Department of Planning + Urban Design

To: Board of Zoning Appeals
From: Planning and Urban Design Staff
Date: March 13, 2023
Re: **Appeal BOZA2022-074**

Property Location: 825 and 827 Minnesota Avenue
Kansas City, Kansas 66101

SITE PLAN OF 825 AND 827 MINNESOTA AVENUE SUBMITTED BY APPLICANT: PROPOSED FLOOR PLAN

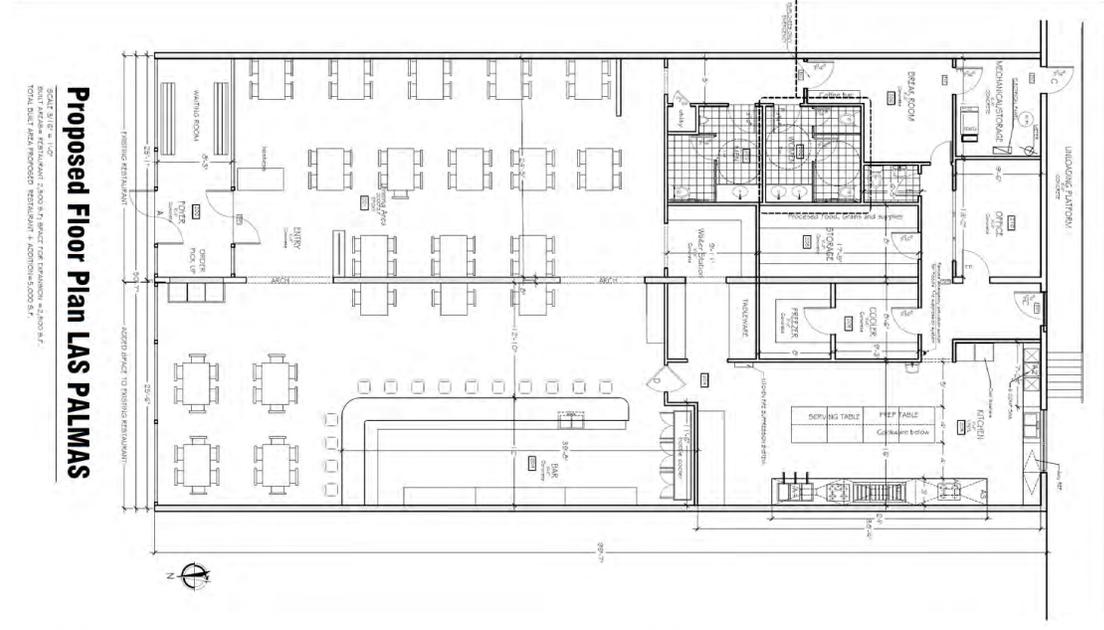
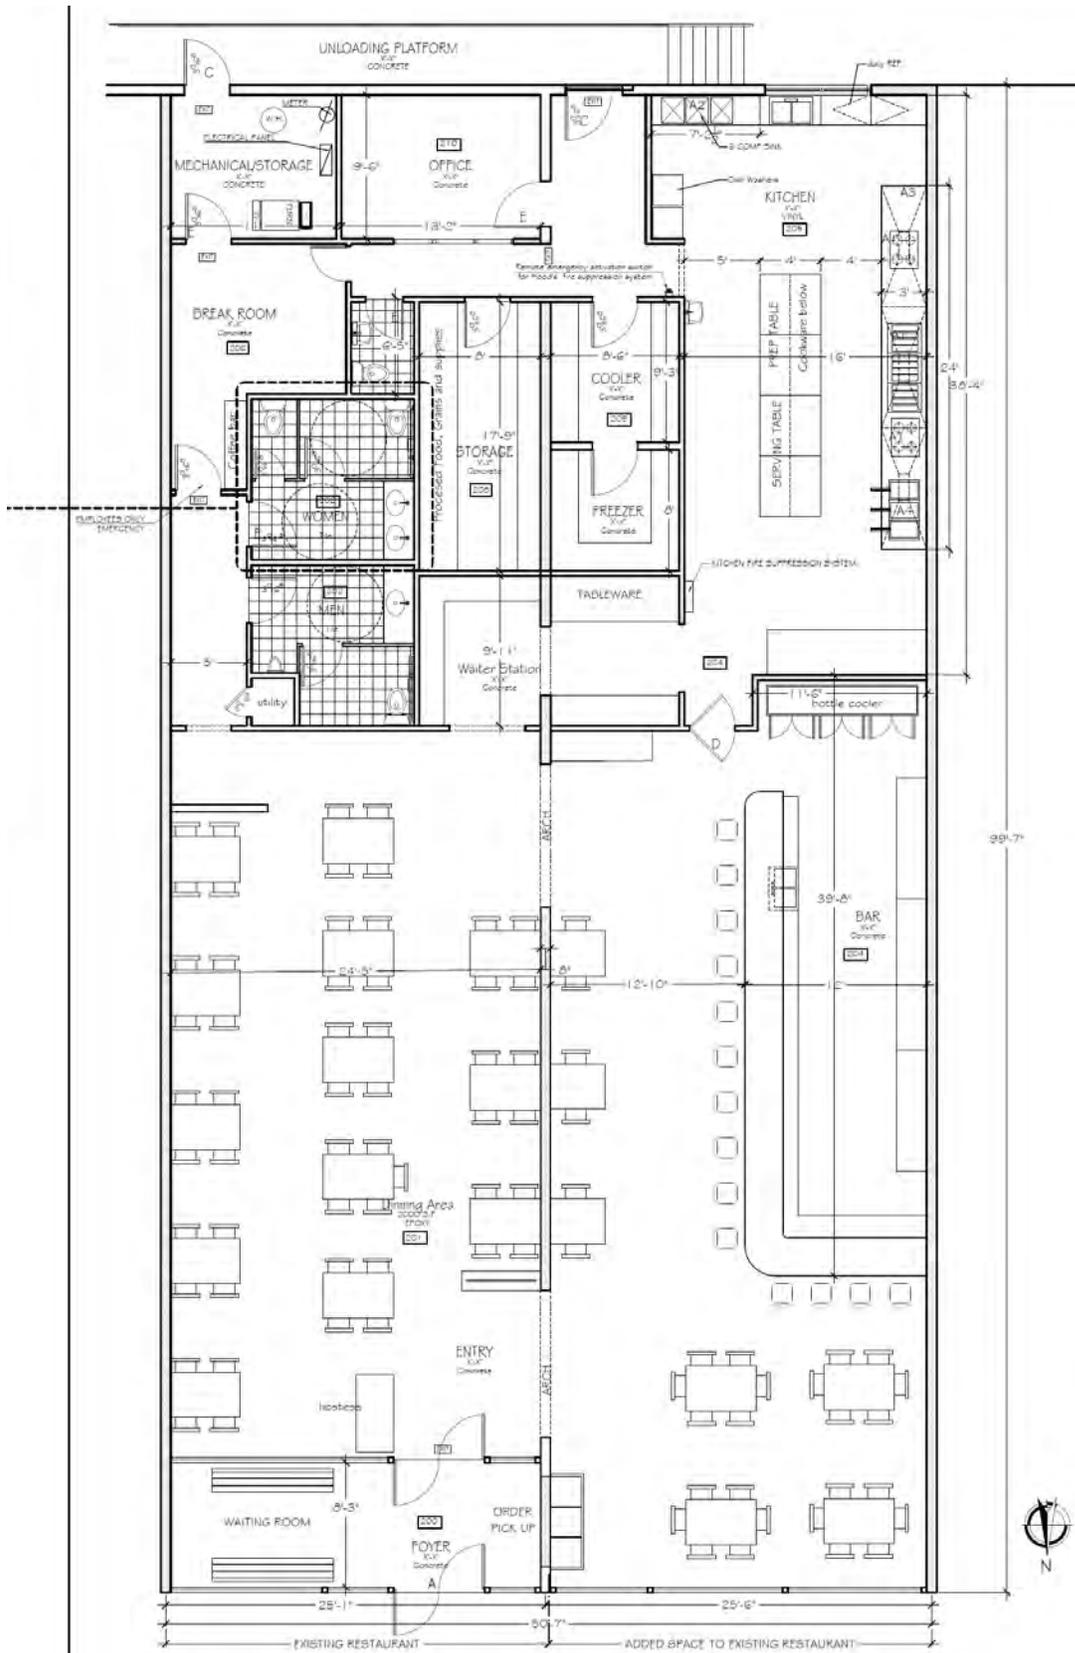
3. What is the current capacity of the restaurant? What will the capacity be after the proposed expansion?

Applicant Response: There is not an [e]stablished max occupancy for this restaurant. However, if table 1004.5 IBC 2018 is applied, the occupancy for the dining area is 1,097 square feet along with the kitchen area (442 square feet) will be 76[.] The maximum occupancy after expansion will be 140. (See submitted Plan sheet #2)

Staff Response: Applicant has submitted a revised site plan, which can be found under "Site Plan of 825 and 827 Minnesota Avenue Submitted by Applicant: Proposed Floor Plan" within the *Attachments* section of this report.

**SITE PLAN OF 825 AND 827 MINNESOTA AVENUE SUBMITTED BY APPLICANT:
PROPOSED PARKING PLAN**

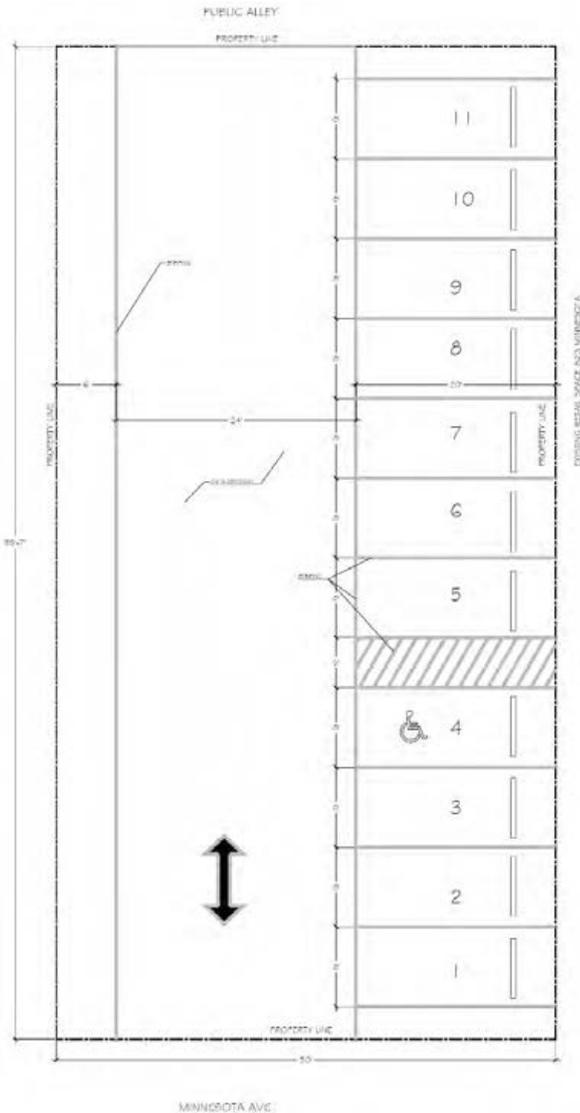
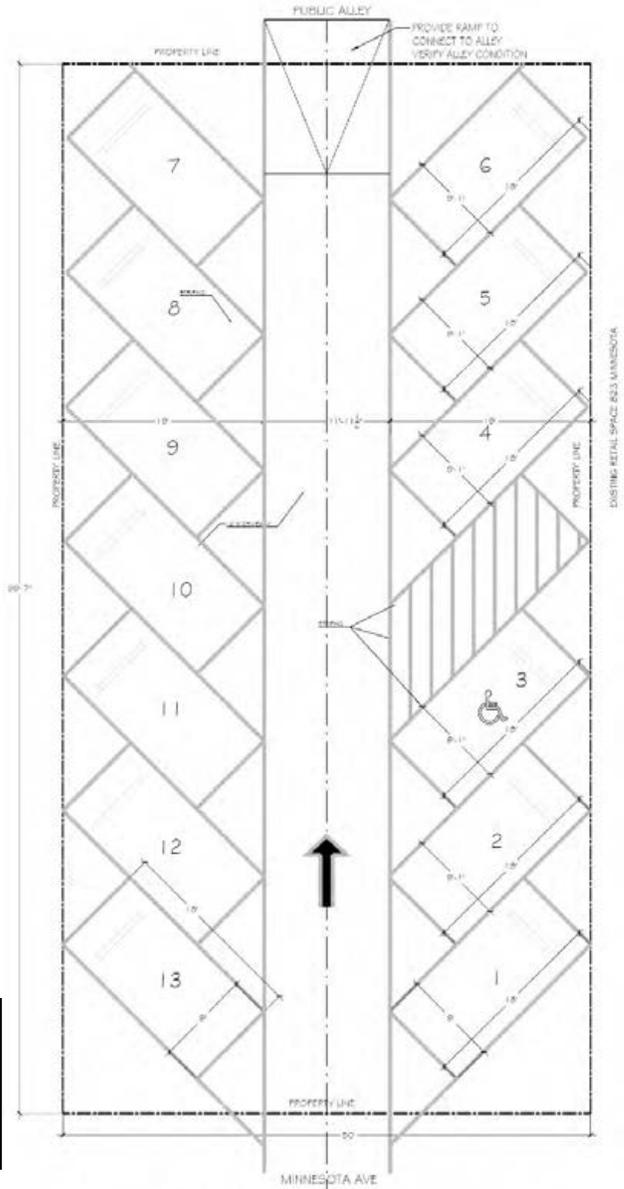
1. The adjacent parking lot measures 50 feet wide by 100 feet deep. Submitted site plans demonstrate 11 designated parking spaces, all striped as head-in parking

at 90 degrees. Submit a revised site plan and/or a separate parking plan with an arrangement providing more than 11 parking spaces. Section 27-699(a) provides standard parking cross dimensions for seven (7) distinct parking arrangements:

5. Per the Downtown Area Master Plan, the surface parking lot must be screened by a combination of fencing and shrubs. Provide either a screening key as part of

a revised site plan or a separate landscaping/screening plan for the parking lot parcel.

Applicant Response: The size and shape of the parking lot allows for...a single loaded aisle which will allow for 11 vehicles parking;...and a 45 degree pattern double loaded aisle (49") with one way drive into the public alley (see attached plan)[.]

Staff Response: Applicant has submitted a revised parking plan, which can be found under "Site Plan of 825 and 827 Minnesota Avenue Submitted by Applicant" within the *Attachments* section of this report.

Applicant Response: See attached revised Parking lot feasible options.

Staff Response: Applicant has submitted a revised parking plan, which can be found under “Site Plan of 825 and 827 Minnesota Avenue Submitted by Applicant” within the *Attachments* section of this report.
